**BEFORE THE INDEPENDENT HEARING PANEL APPOINTED BY THE  
QUEENSTOWN LAKES DISTRICT COUNCIL**

**UNDER** the Resource Management Act 1991 (RMA)  
**IN THE MATTER** of the Te Pūtahi Ladies Mile Plan Variation in accordance  
with section 80B and 80C, and Part 5 of Schedule 1 of the  
Resource Management Act 1991.

**STATEMENT OF EVIDENCE OF MICHAEL [XX] LOWE  
29 September 2023**

# Revised Eastern Boundary Study Precinct Boundaries 27 Sep 2023 r.A

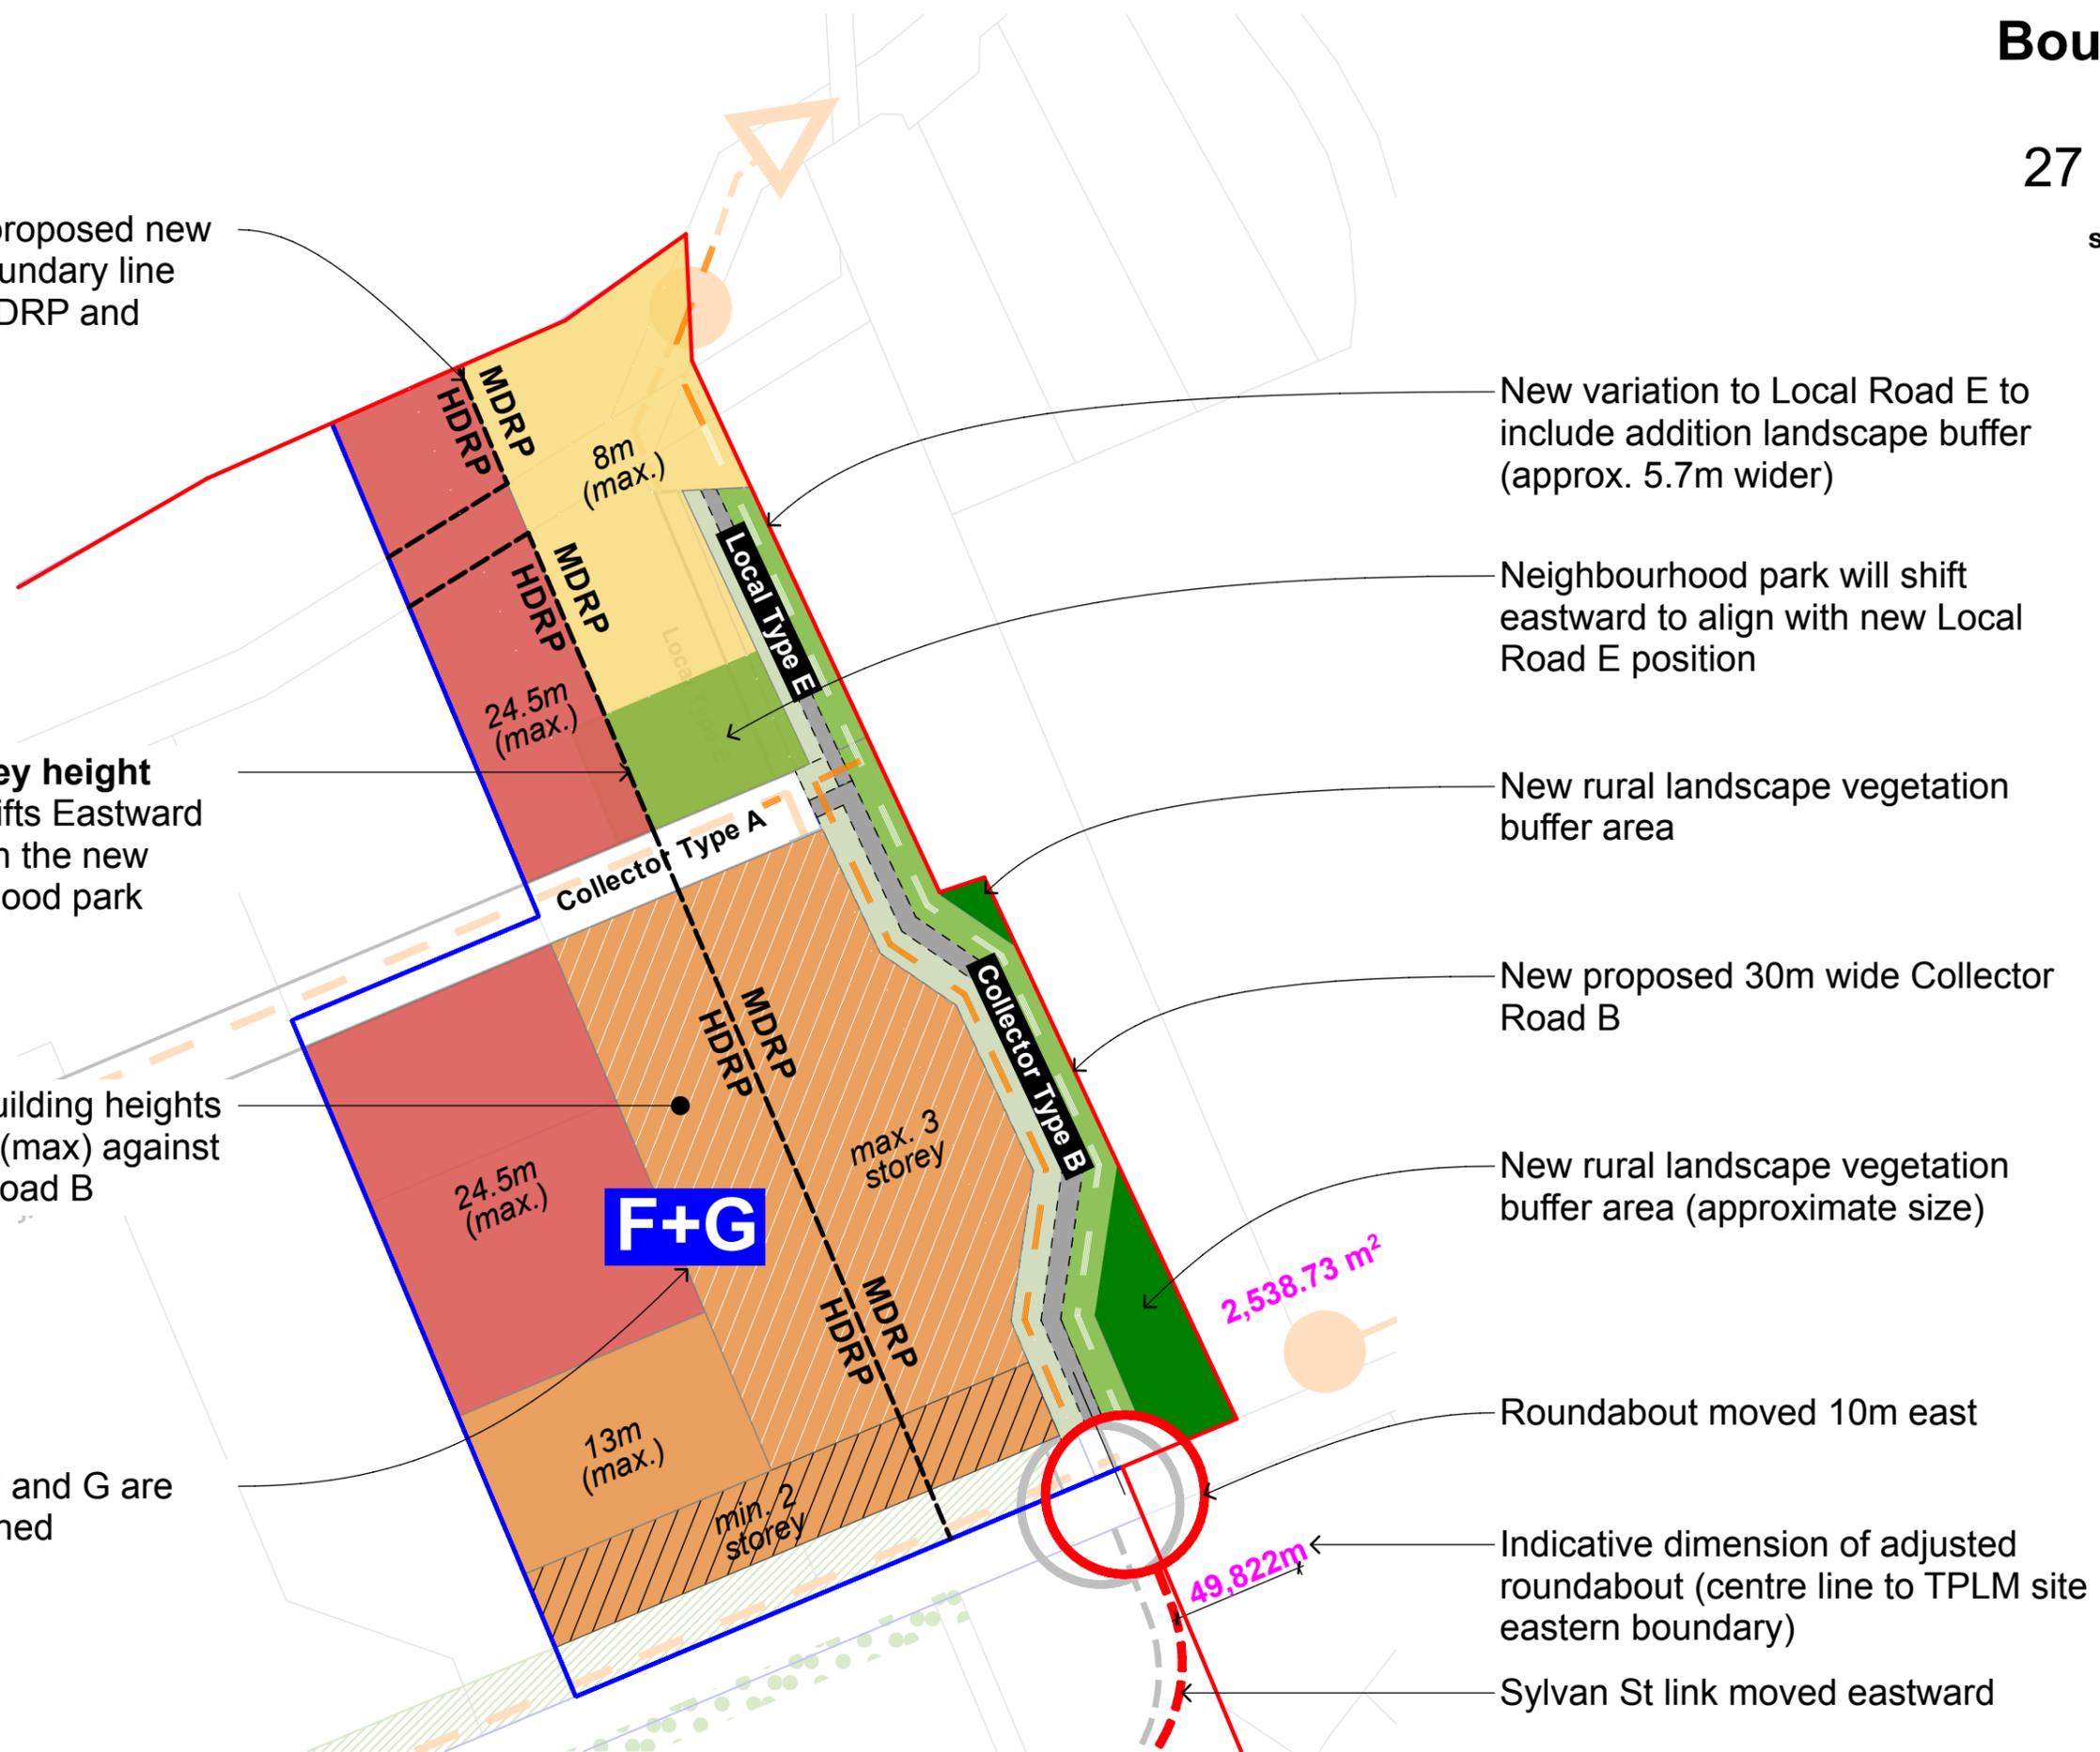
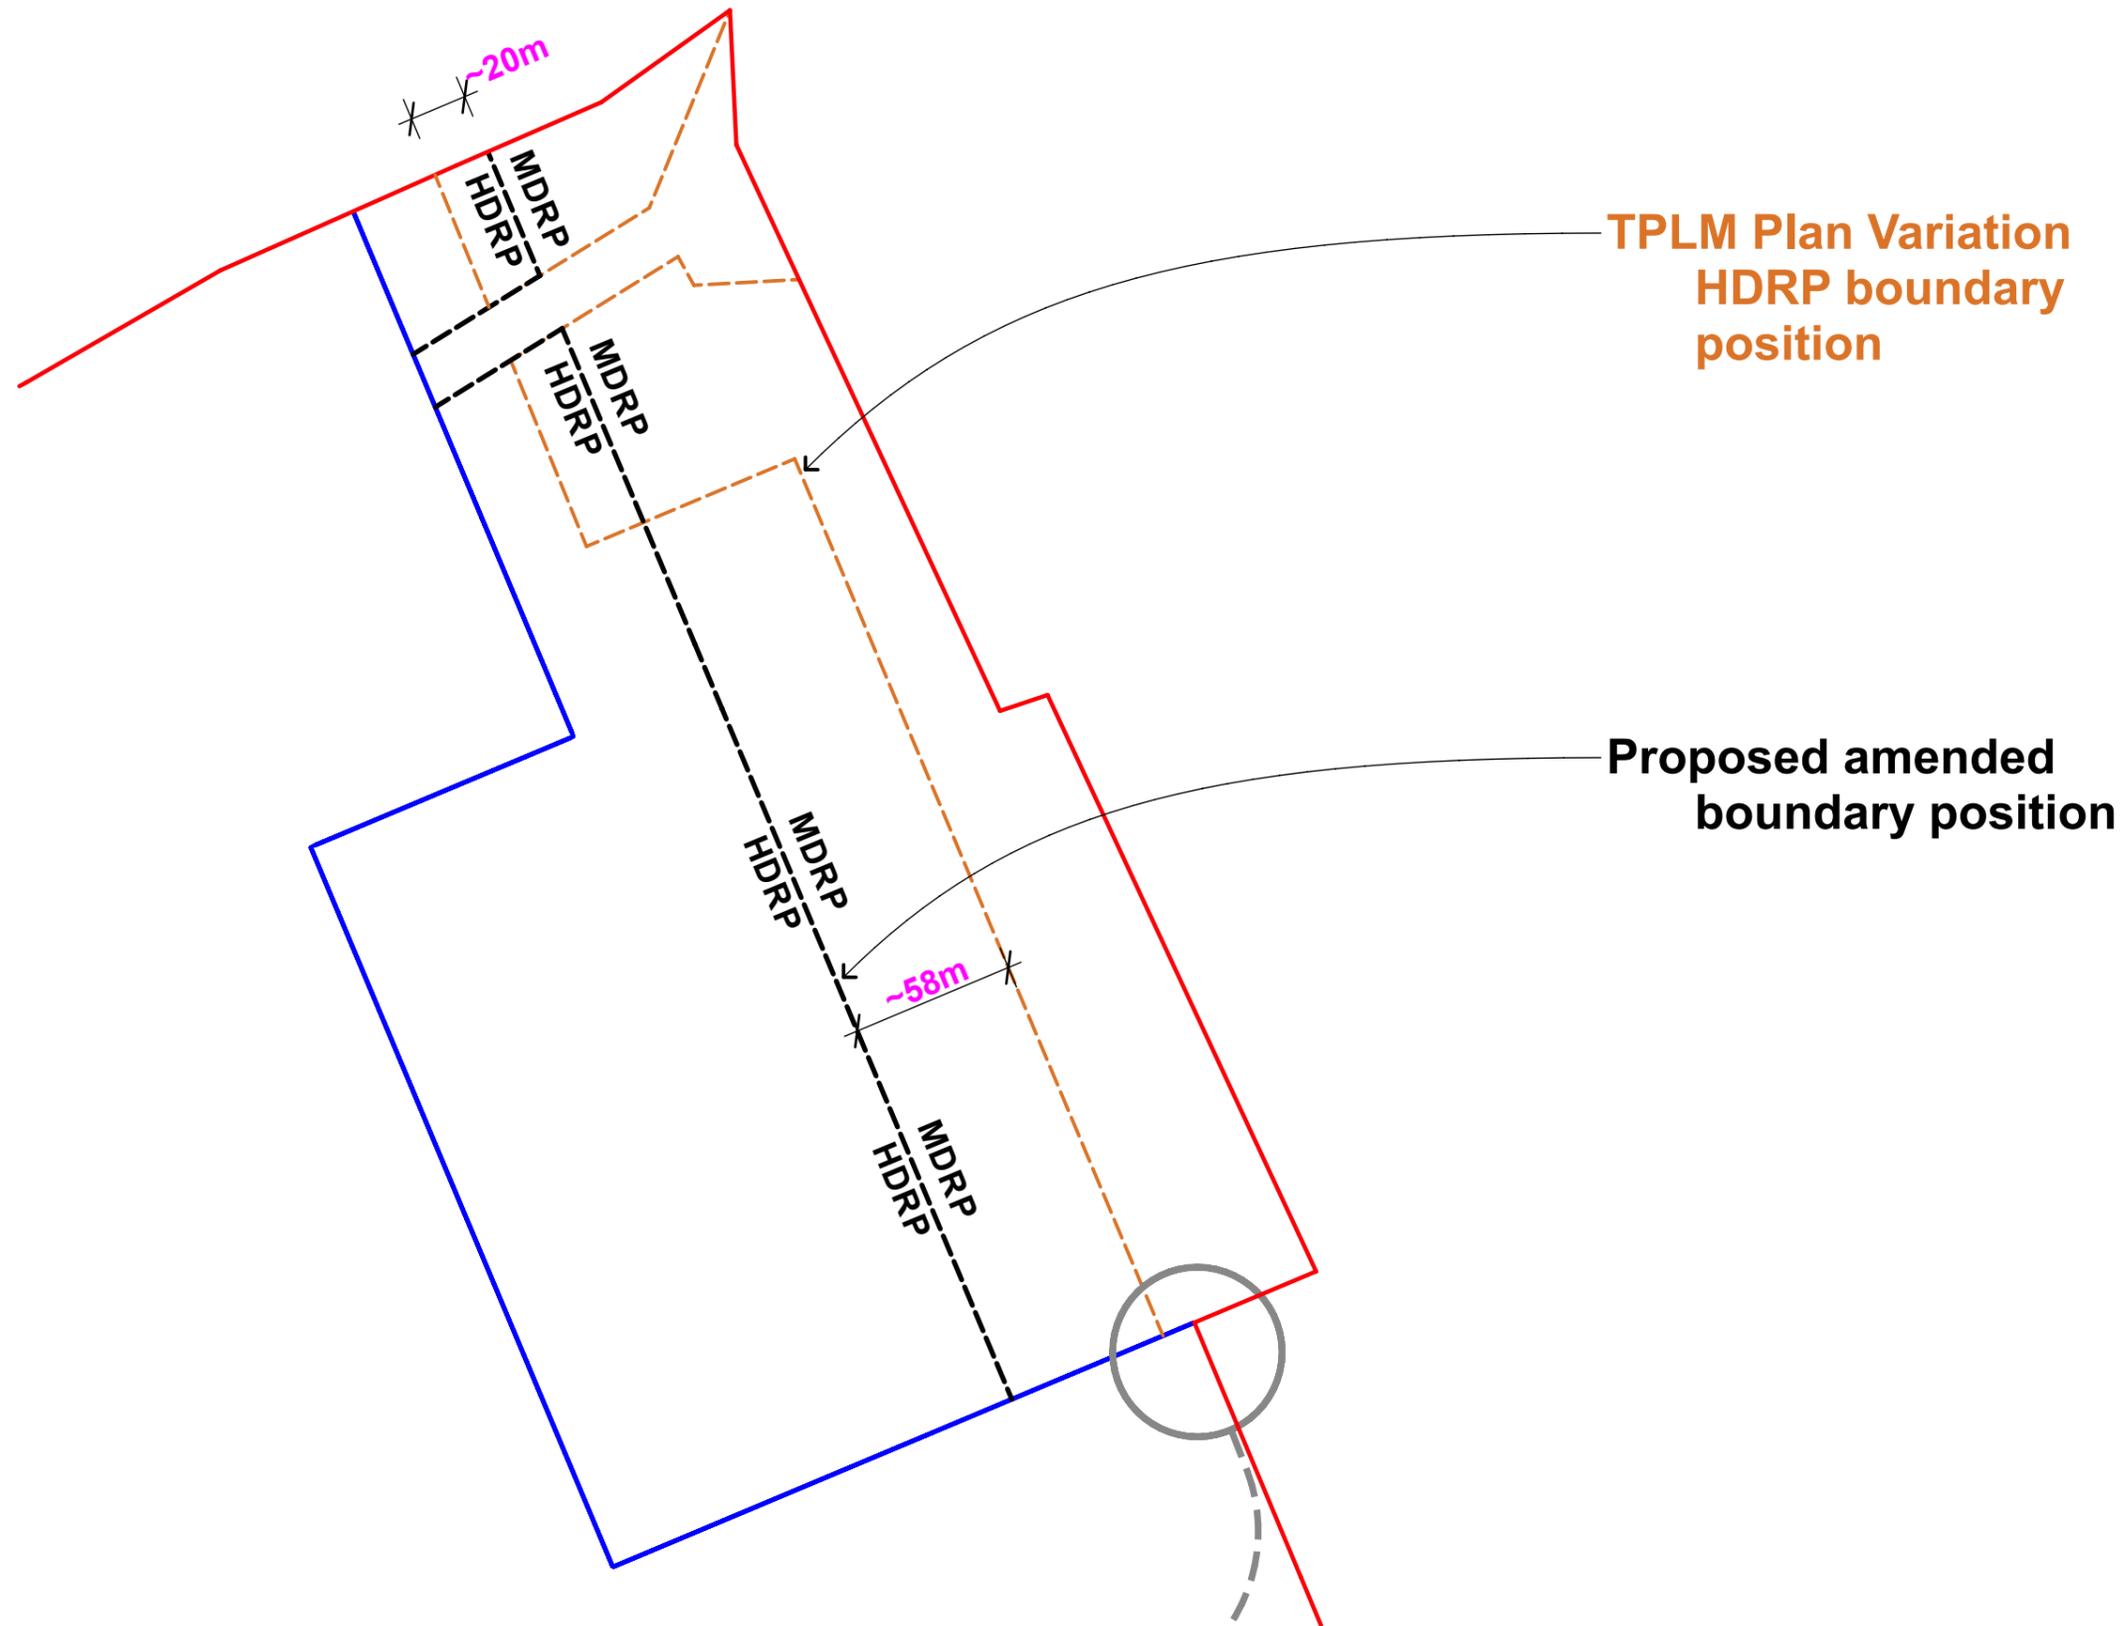
New rural landscape vegetation buffer area (approximate size)

Roundabout moved 10m east

Sylvan St link moved eastward

Sub Area F and G are now combined

# Revised Collector Road Type B Cross Section 19 Sep 2023 r.B

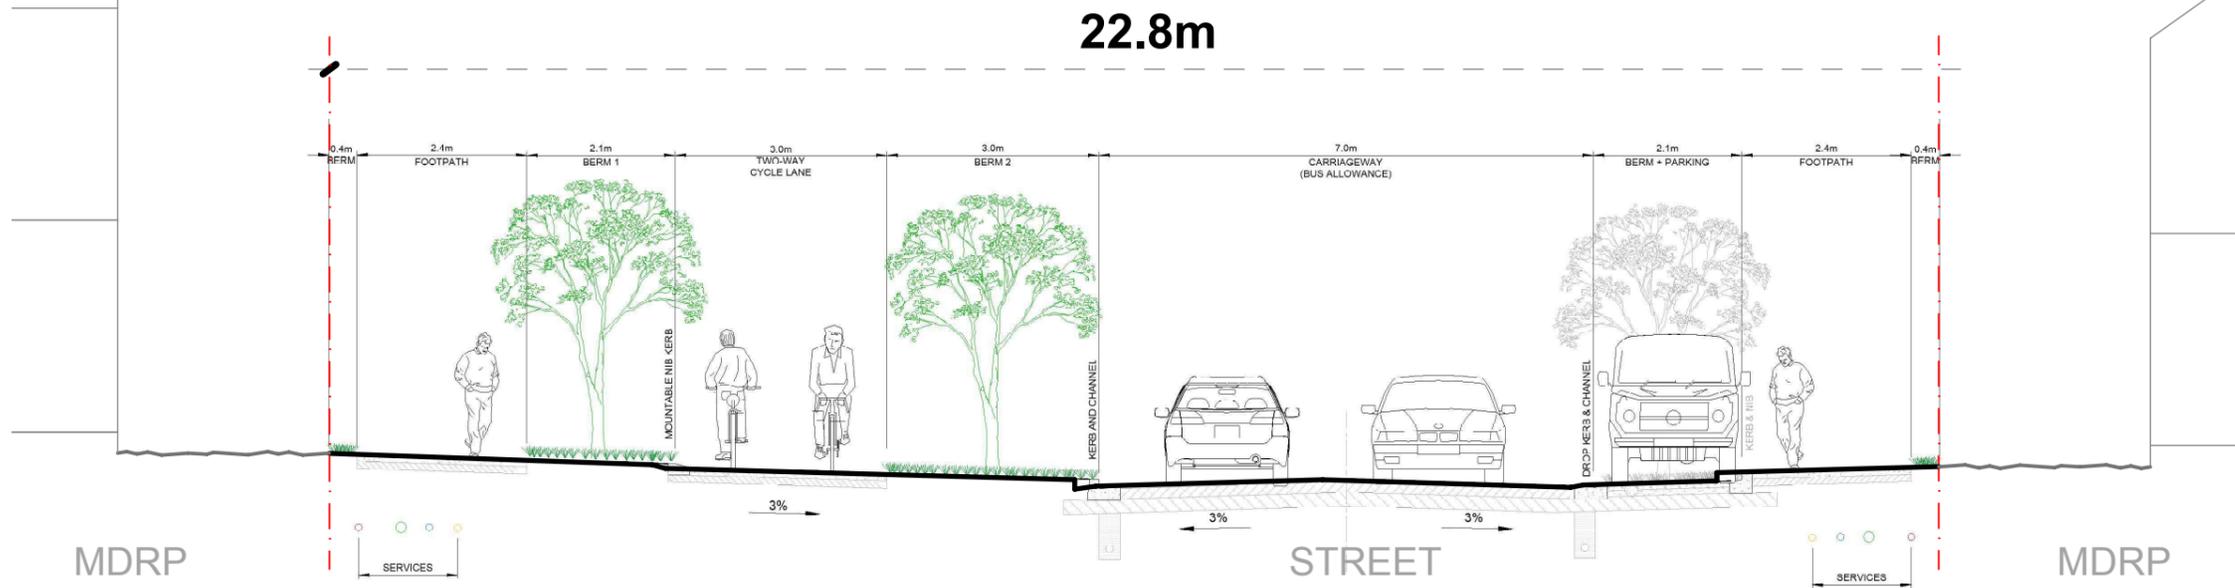
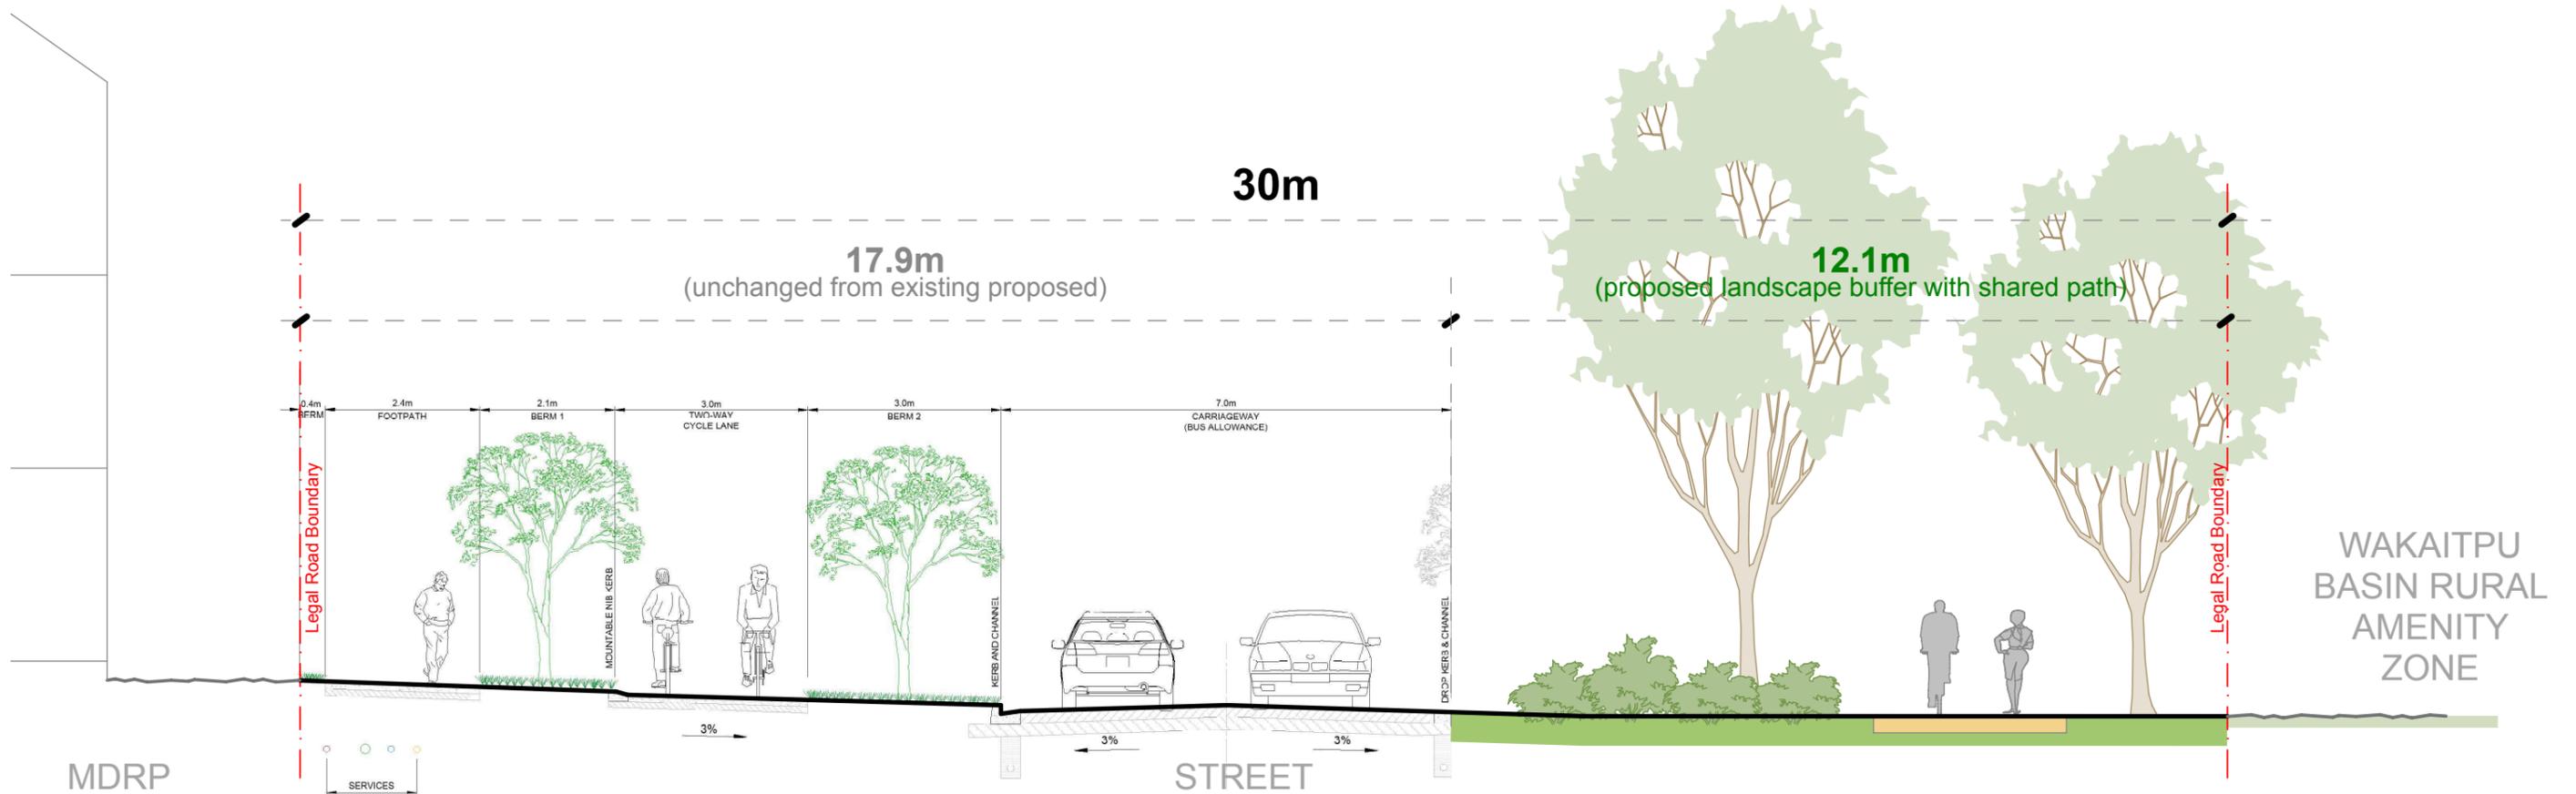
102 In response to submission seeking greater mitigation of the visual impacts on rural character and natural landscape,<sup>3</sup> I see value in improving the key rural gateway threshold point at the eastern most boundary in Sub area G where the TPLM site will be most visible to people arriving from Lake Hayes. I recommend the following change (refer to figure 10 below, and to **Appendix A** for a larger image). which would achieve improved visual outcomes for the structure plan by:

- (a) Providing for a well-designed landscape edge to the adjacent rural zone which would provide good vegetation screening with an attractive layering of planting and trees of a scale respectable to the adjacent TPLM built form, and of a landscape character similar to the existing large shelter belt
- (b) improving the general public's outlook to adjacent rural land by creating a new public street along the rural boundary that offers a new experiential view point.

Section currently shown in TPLM plan variation

Newly proposed Collector Rd B section
